Title: Dana® Spicer® Steer Knuckle Recall Process

Date: September 7, 2017

ABIB-1701

Topic: Steer Knuckle Recall Process – Recall Number 17E041

Check Nut Torque – Do Not Exceed 170 ft. lbs.

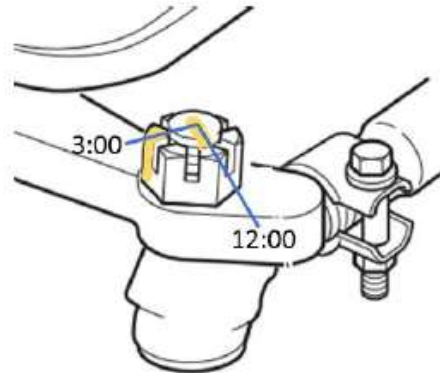
3. With someone in the cab of the truck turning the steering wheel (engine off) just enough to cause movement in the wheels, document how much movement is found on each side of the steer axle. Record results on the supplied form.
4. The next step is to remove the cotter pins and check for proper nut torque. Put a paint mark across one side of the nut and top of the stud. With a torque wrench and a 1 ¼" socket, torque the nut in a clockwise (tighten) direction until the nut just starts to rotate or you reach 130 ft. lbs. **Important: Do not exceed 170 ft. lbs.** Record your findings on the recall form.

5. If there is no rotation of the nut at 130 ft. lbs. install a new cotter pin and return the truck to service.
